ECM Calibration: Hesitation Concerns

Service
Category Engine/Hybrid System

Section Engine Control

| YEAR(S) | MODEL(S) |
|-------------|----------|
| 2016 - 2017 | RX350 |

Figure 1. Location of Authorized Modification Label for 2016 – 2017 RX 350

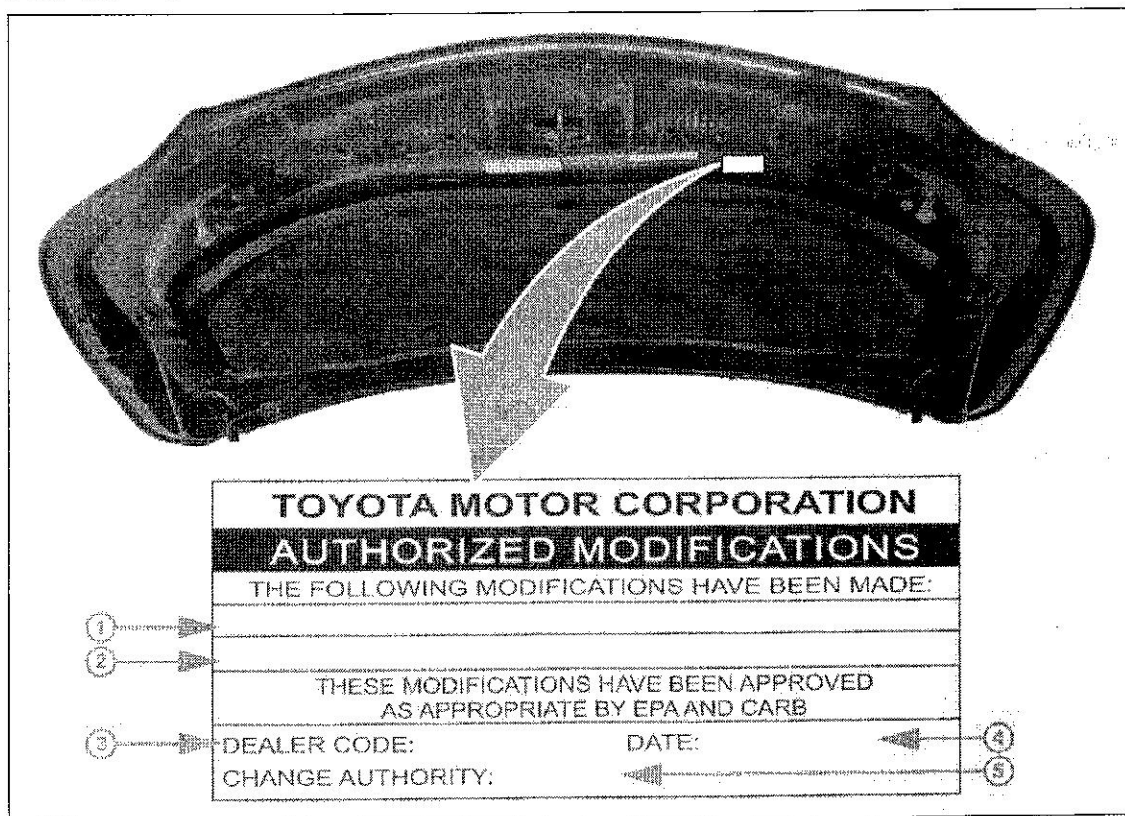
1. Does the vehicle exhibit standing start hesitation, passing hesitation during freeway/city driving and/or low speed area reacceleration hesitation?
 - **YES** – Go to step 2.
 - **NO** – This bulletin does NOT apply. Continue diagnosis using the applicable Repair Manual.
2. Check for the Authorized Modifications Label affixed to the vehicle in the location shown below. Confirm if the ECM (PCM) calibration has been updated.

Is the calibration ID listed NOT the latest ECM (PCM) calibration?

B. Affix the Authorized Modifications Label to the vehicle at the location shown in Figure 1. The Authorized Modifications Label is available through your facing PDC, P/N 00451-00001-25.
